MEMORANDUM

Date: April 9, 2021
To: Water Right File 65-23311
From: Michele Edl
Re: heating cooling use recommendations

I was asked to review and corroborate the field examiner's recommendations for the heating and cooling uses authorized by this right.

HEAT EXCHANGER SCHEDULE

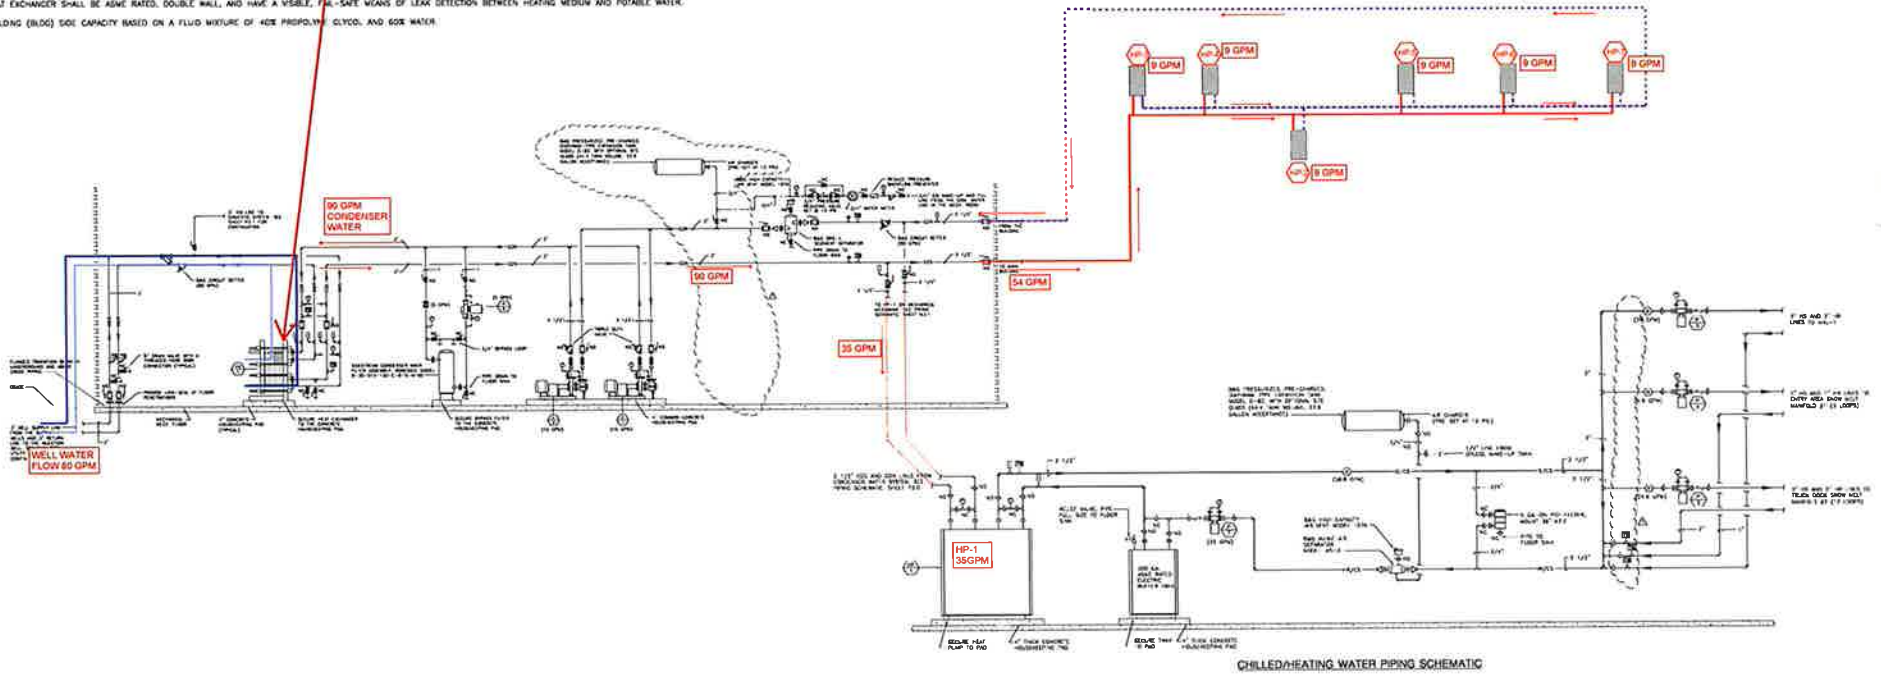
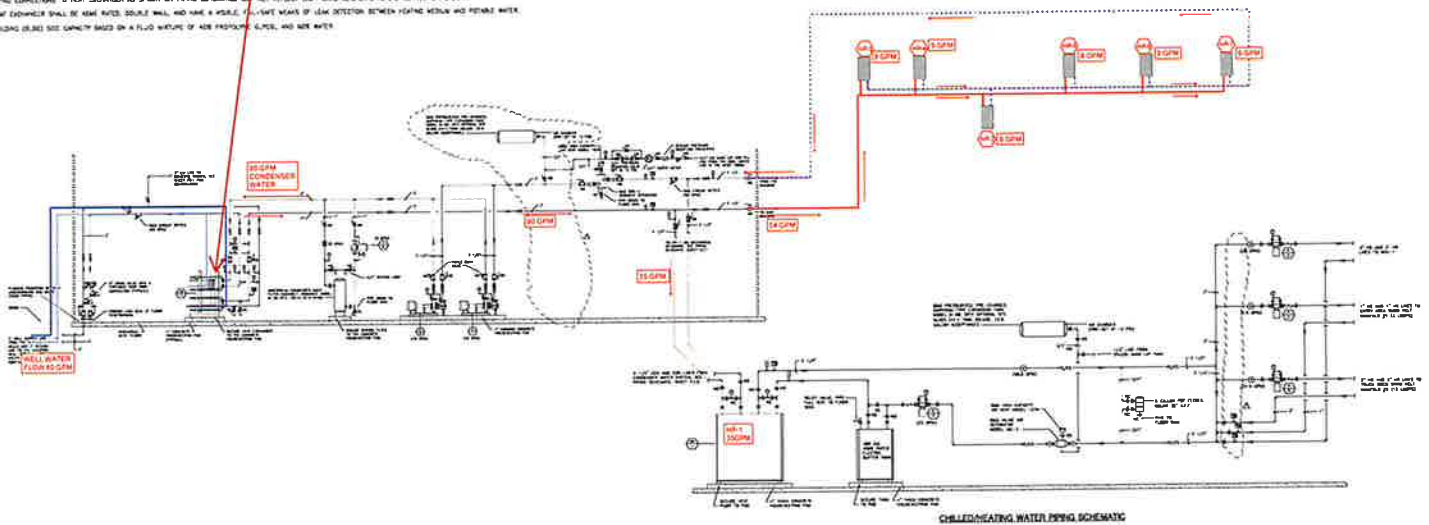
After several email exchanges, I discovered that the water from the well only supplies water to the heat exchanger at a rate of 80 gpm or 0.18 cfs. Therefore, the heating diversion rate will be limited to 0.18 cfs. Mr. Boggs recommended 0.21 cfs for the heating use, because he thought the 90 gpm of water being diverted in the closed loop system should be added onto the 80 gpm of the water being diverted from the well into the heat exchanger. The heater exchanger is the only heating unit that requires water flow from the well, since the heat pump system is self-contained. Therefore, Mr. Boggs' original recommendation was not correct. It needs to be limited to the 80 gpm diverted through the heat exchanger only.
